Re: Incorrect Thermal broken Aluminum Joinery: 2 Rapare St. Job No.27363 - JSR Construction.

From: **Matt McLelland** <matt.mclelland@hagley.co.nz>
Date: Thu, Nov 24, 2022 at 12:37 PM
Subject: 27363 - 2 Rapera Street
To: Ricky Wong <jsrconstruction.nz@gmail.com>
Cc: Tom Ashwin <tom.ashwin@hagley.co.nz>

From: Tom Ashwin <tom.ashwin@hagley.co.nz>
To: Harry Lo <harrykhlo@gmail.com>
Cc: "jsrconstruction.nz@gmail.com" <jsrconstruction.nz@gmail.com>
Bcc:
Date: Mon, 31 Oct 2022 01:01:48 +0000
Subject: JSR Construction Job No.27363: 2 Rapare Street, Rolleston.

Photo 3 – Typical slide door frame shows that the slide door does not have thermally broken

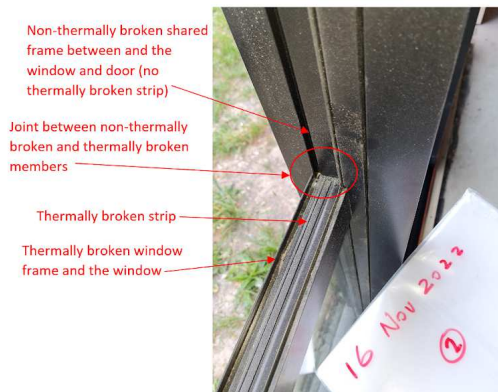
- c) Photo 3 – Typical slide door frame shows that the slide door does not have thermally broken strip
 - d) Photo 4 – Indicating the non-thermally broken parts of the Sliding Door “Living D6” (Door number referred to the attached quote no. 27363) (Trim Size: 2130 x 2700; Area: 5.751 m sq.)

Photo 1 – Indicating the non-thermally broken parts of the Sliding Door “Lounge D6” (Door number referred to the attached quote no. 27363) (Trim Size: 2130 x 2700; Area: 5.751 m sq.)

Photo 2 – Typical joint between the vertical frame of the sliding door and the horizontal frame of the window shows that the shared frame between the door and the window do not have the thermally broken strip.

Figure 1 - Photo location plan

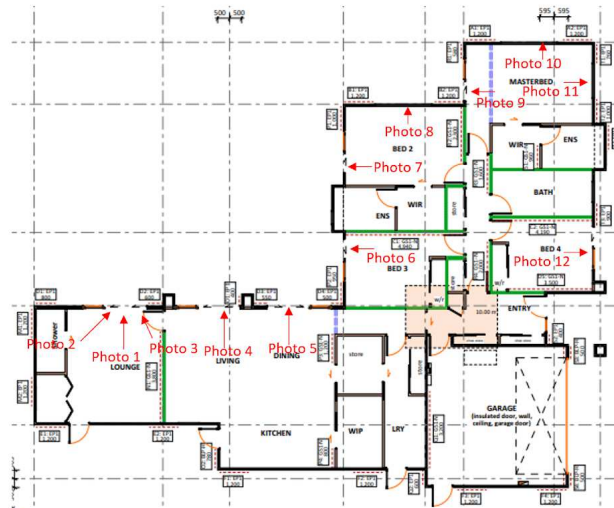
and uncertain products are stated below with the corresponding photos and the photo location plan (Figure 1 below). The product quote no. 27363 from your subcontractor attached for your reference.

- 1) The parts of the windows and doors frames do not have the thermally broken strip. These windows and doors make up 59% of the area of all the aluminium joinery products. The total area of these problematic aluminium joinery is 28.8 m sq. The total area of all aluminium joinery products is 48.6 m sq. These problematic products are shown in the following photos (note that the photos and the location plan are given at the end of this email):

- 2) The frames of the windows that we are not sure if they are thermally broken or not since the depths of those window frames seems to be smaller than others 32% of the thermally broken joinery by comparing the distances between the frames and the internal and external walls. The total area of these uncertain aluminium joinery is 4.2 m sq. (8.7 % of the total area). These products are shown in the following photos:
